Proposal for amendments to ECE/TRANS/WP.29/GRVA/2020/22

This document aims to provide an overview of all working and informal documents aiming to amend UN-R79 ACSF of category C.

ACSF C – Case where the lateral movement is initiated automatically (1 Step HMI)

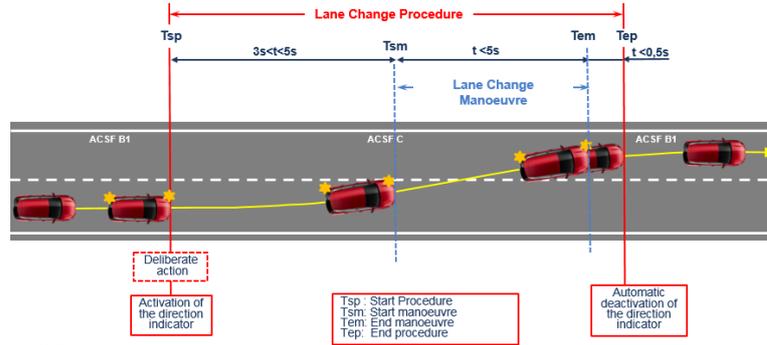
- 5.6.4.6.4.1. Automatic initiation of the lane change manoeuvre
- In case of an automatic initiation the lane change manoeuvre shall commence between 3.0 seconds and ~~7.0~~ ~~5.0~~ seconds after the manual activation of the procedure as described in paragraph 5.6.4.6.2. and shown in the Figure below. **The manoeuvre shall commence at the earliest opportunity without undue delay when the situation is not deemed critical as defined in 5.6.4.7.**

ACSF C – Case where the lateral movement is initiated by a second deliberate action by the driver (2 Step HMI)

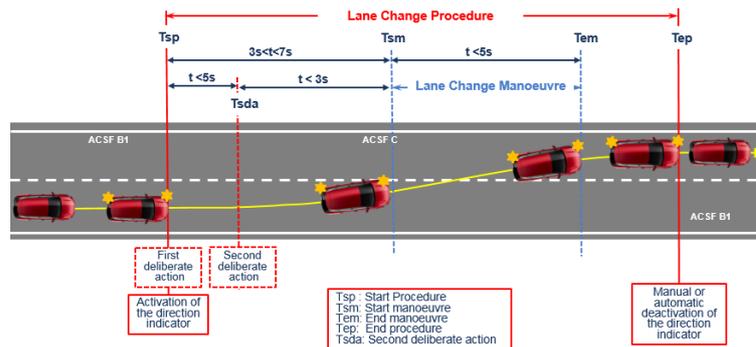
In case of an initiation by a second deliberate action the lane change manoeuvre shall commence between 3.0 and 7.0 seconds after the manual activation of the procedure as described in paragraph 5.6.4.6.2.

Additionally, the lane change manoeuvre shall commence at the latest 3.0 seconds after the second deliberate action as shown in the Figure below.
